DRG. W3-21B

WATERMAN STEAMSHIP CORPORATION
MOBILE ~ ALA.

GULF SHIPBUILDING CORPORATION
MOBILE ~ ALA.
HULL NOS 1, 2, 3, & 4.

STRUCTURAL PROFILE AND DECK SCANTLINGS

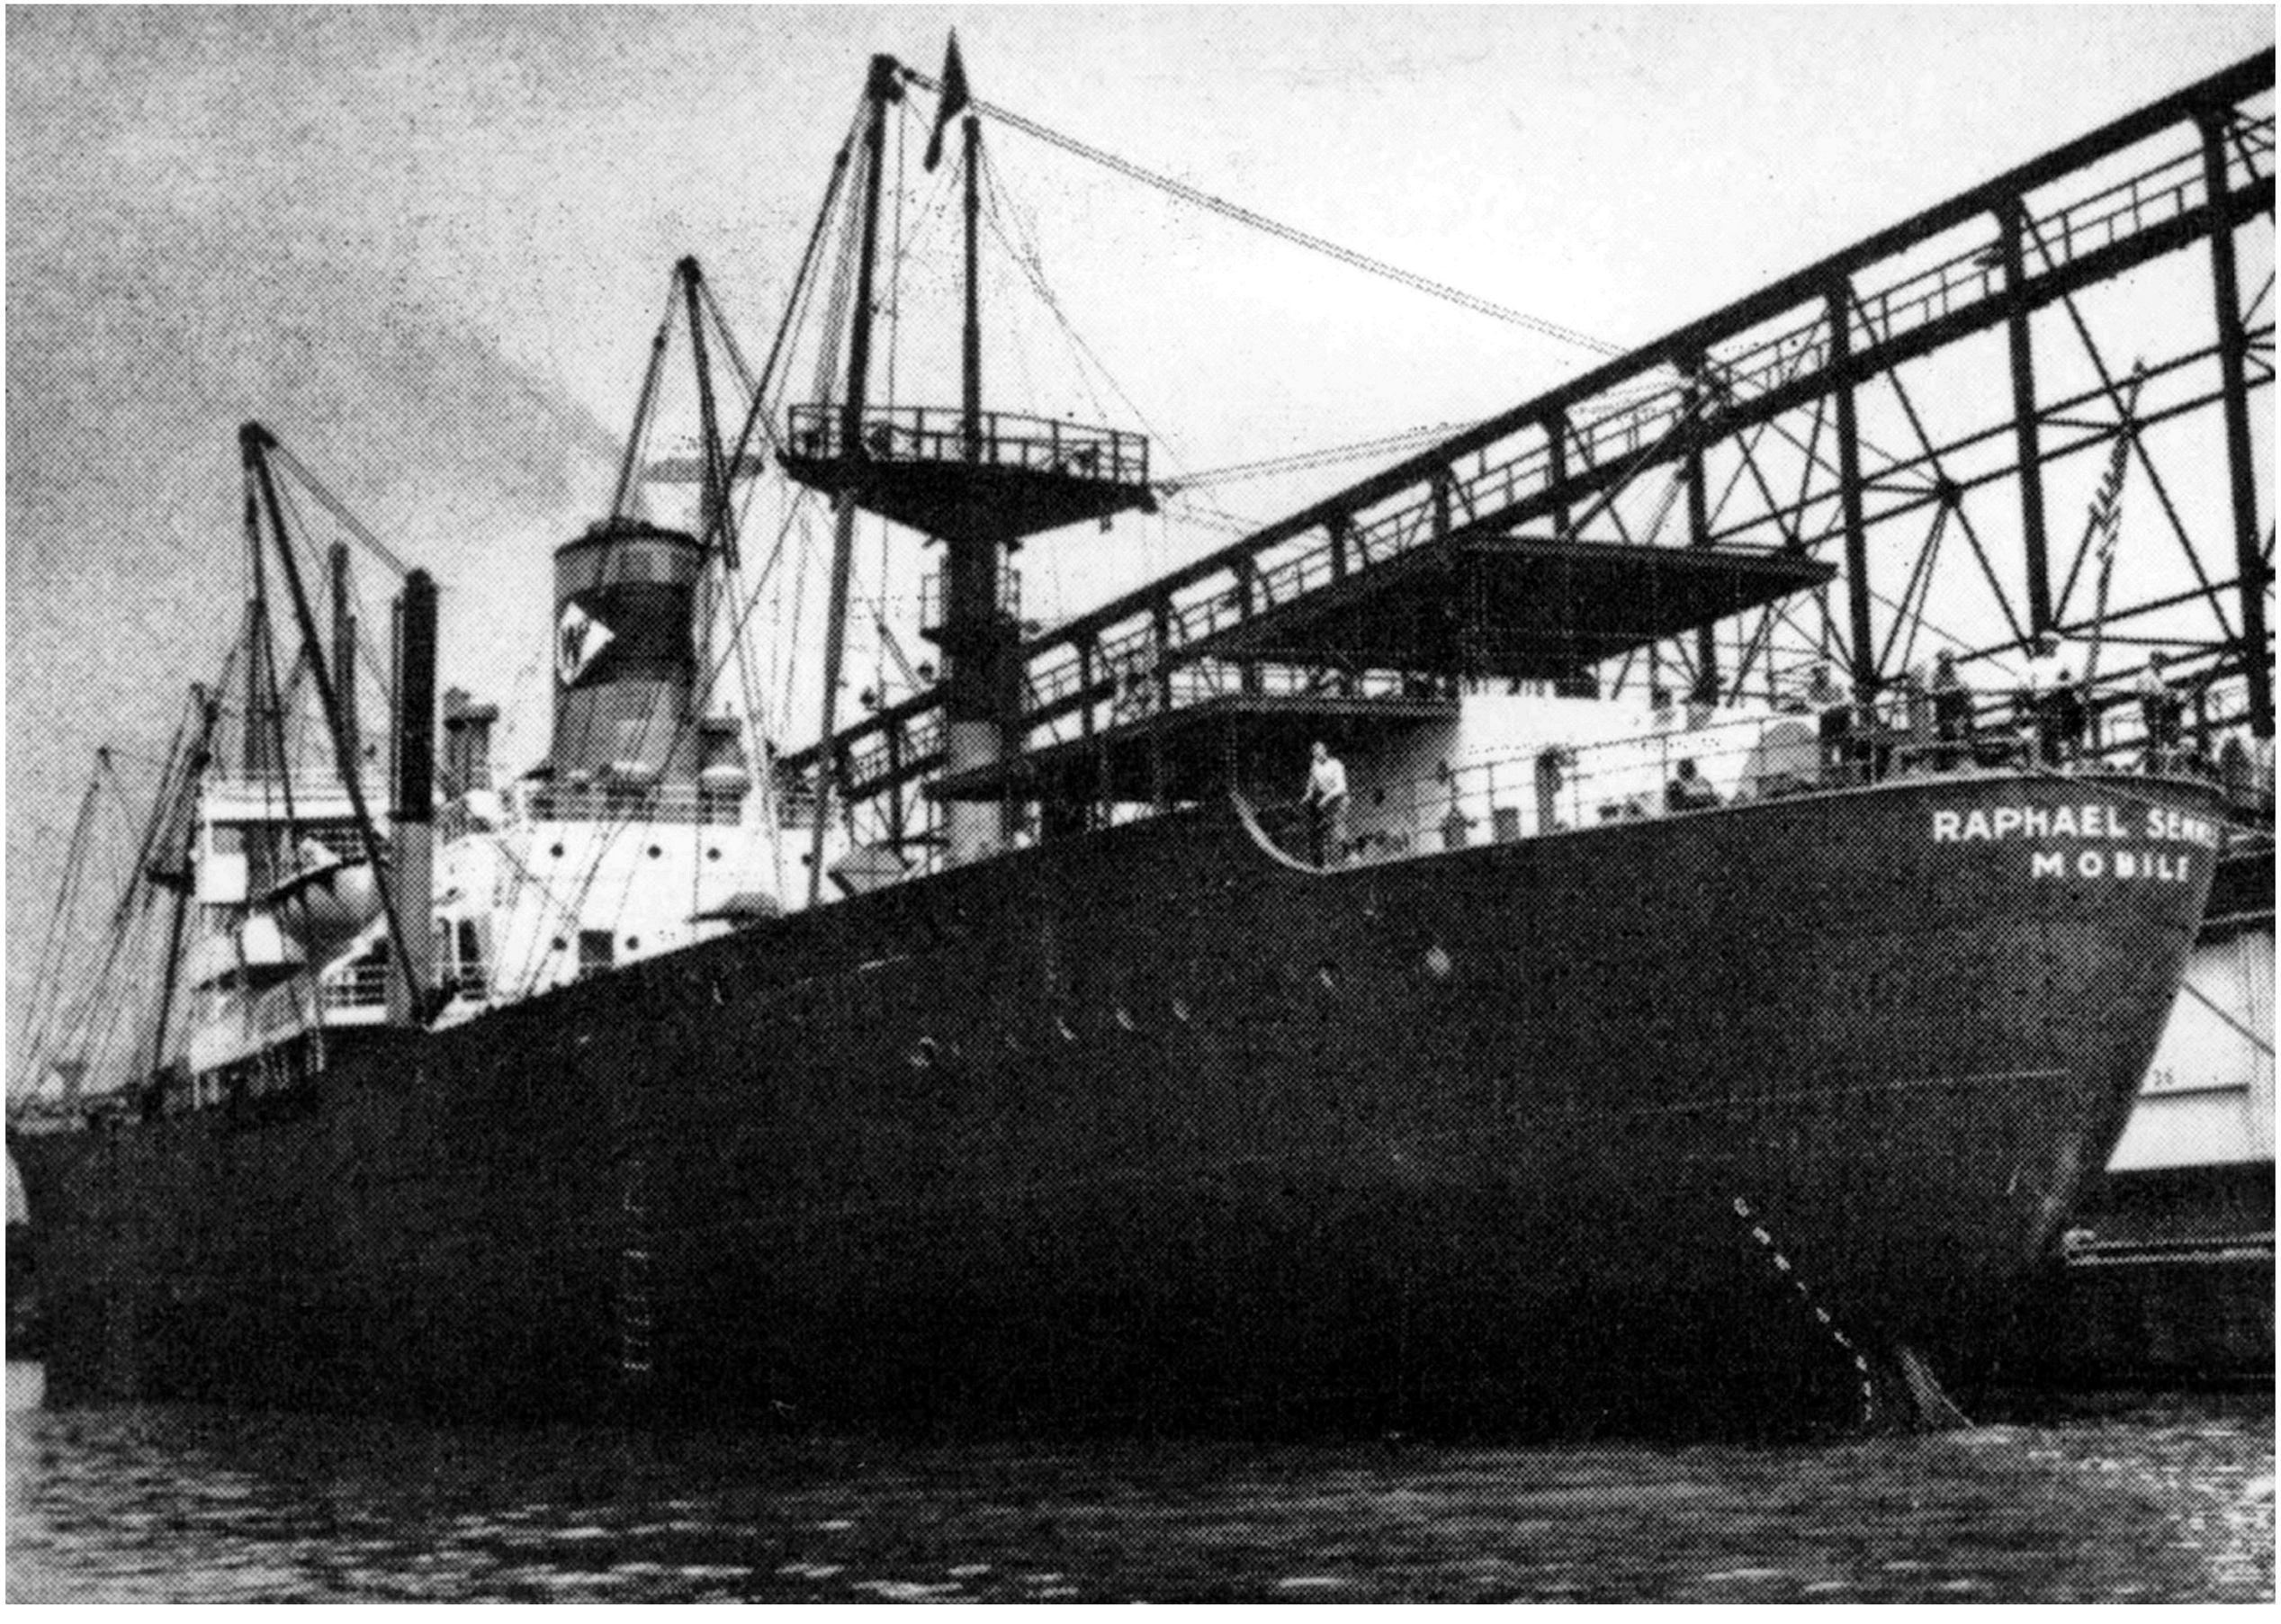
ALTER	ITEM	PANEL	DESCRIPTION	BY	APPR'VD
G¹	1²	2'&3'	GIRDER SD-9A AND DETAIL ADDED	R.T.R.	
F²	1²	1²	BRACKET-GIRDER LAP CHANGED 2" TO 4"	R.T.R.	
	6'	4'	GIRDERS SD-12 & SD-13 CONSOLIDATED		
	5'	2'	℄ GIRDER NOTED - SHELTER DK. FRS. 8-15		
E²⁵	4'	4'	PILLAR AT FR. 140-141 MODIFIED		
	3'	1'	SECT. OF SHELTER DK. RAISED PLTFM. CHANGED	R.T.R.	
	2¹⁵	1',2',5'	DETAILS OF GIRDERS CHANGED		
	1⁶	4'&3'	LOCATION OF H-COLS. CHANGED & SIZES NOTED		
D¹	1⁶		GIRDER NOS. CHANGED ON SHEL. DK.		
C²	2⁴	4	WEB FRMS. 121, 129, 133 & 137 MOVED		
	1⁷	3,4	BHDS. 116, 119, 145, & 156 MOVED FORD.		
B⁶	6²	3,4	BRACKETS ADDED		
	5²	2	PANTING STRINGERS ADDED		
	4¹⁵	2,3,4	THICKNESS OF PLATING CHANGED		
	3⁹	2,3,4	ALTERED SIZE OF PILLARS		
	2³	2	ADDED WEB FRMS. 19, 23 & 29		
	1⁴	1	INCREASED SIZE OF DK. BEAM		
A²	2⁹	1,4,5	NEW SECTIONS OF GIRDERS ADDED		
	1¹⁰	1,2,3,4,5	ALL GIRDERS MODIFIED

ALTER	ITEM	PANEL	DESCRIPTION	BY	APP'D
H	10	5	HEIGHT OF BROW ℞ - 3RD DK. CORRECTED	O.L. 5-9-41	
	9	4	DK. ℞ REDUCED FR. .38" TO .33" ℞ (SHELT. DK)		
	8	5	TRANSOM LOCATION CORRECTED		
	7	5	SD-16 - REVISED		
	6	4	SD-10 CORRECTED - INCREASED UNDER DK. HOUSE		
	5	4	ANGLE WELDED TO DK. BEAM - FR. 122		
	4	3	SIZE OF H-COLUMNS RESERVED - T.T.		
	3	1	2D-5 - 2D-14 - FACE ℞ INCREASED FR. 1" TO 1.25" ℞		
	2	1	GIRDERS 2D-5 - 2D-14 - COAM. ℞ REDUCED FR. 1" TO .625"		
	1	1	3"x.625" FACE ℞ ADDED TO GIRDER 2D-13
